## University of Sydney Faculty of Arts and Social Sciences

### Noise Impact Assessment

**University of Sydney Faculty of Arts and Social Sciences - Response to  
Department of Planning Request for Information**

**Figure 1: Site Survey and Monitoring Positions**

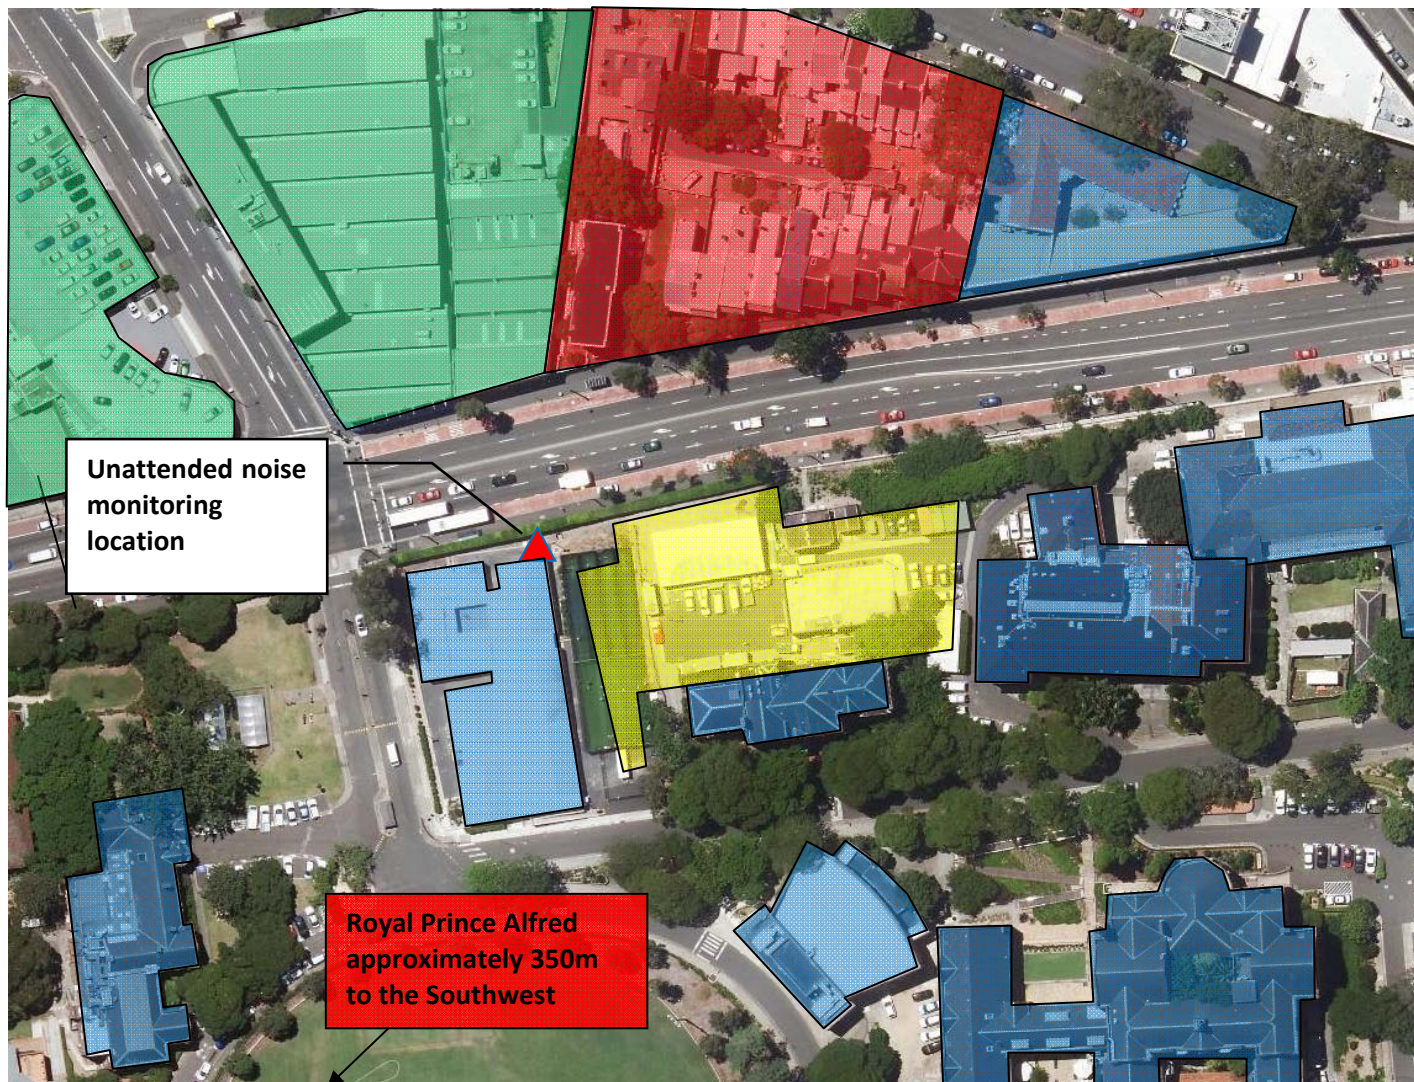
*The Noise Impact Assessment prepared by Acoustic Logic is not considered acceptable for exhibition. The location of noise monitoring adjacent to the development site and not at the nearest sensitive residential receiver does not provide an adequate assessment of background noise levels. Whilst it is acknowledged that the background noise level will be impacted on by existing road traffic noise from Parramatta Road, the Department requires additional background noise monitoring at the nearest sensitive residential receiver be undertaken and factored into a revised noise assessment and conclusions/recommendation.*

As indicated by Figure 1 of the submitted acoustic report, the noise logger was located on University of Sydney grounds approximately 35m to the South of the nearest residential receiver. The location of the noise monitor was determined based on the following:

- The noise logger was concealed from view of the public via the hedge along Parramatta Road and as such provided the highest degree of security from interference and/or theft. The hedge is acoustically transparent and as such would have negligible impact on the measured noise levels. Noise monitoring in front of the of the nearest receiver location to the North is a public thoroughfare and does not provide sufficient opportunity for the monitor to be concealed from the public.

- Notwithstanding above, the ambient noise levels at the logger location and at the nearest receiver location are almost entirely driven by noise associated with Parramatta Road. The nearest affected receiver is susceptible to the same levels of traffic noise as that associated with the logger location. Provided that the noise logger is not affected by any noise source in the immediate vicinity of the site (which it wasn't), the background noise levels will not change when crossing to the other side of the road.
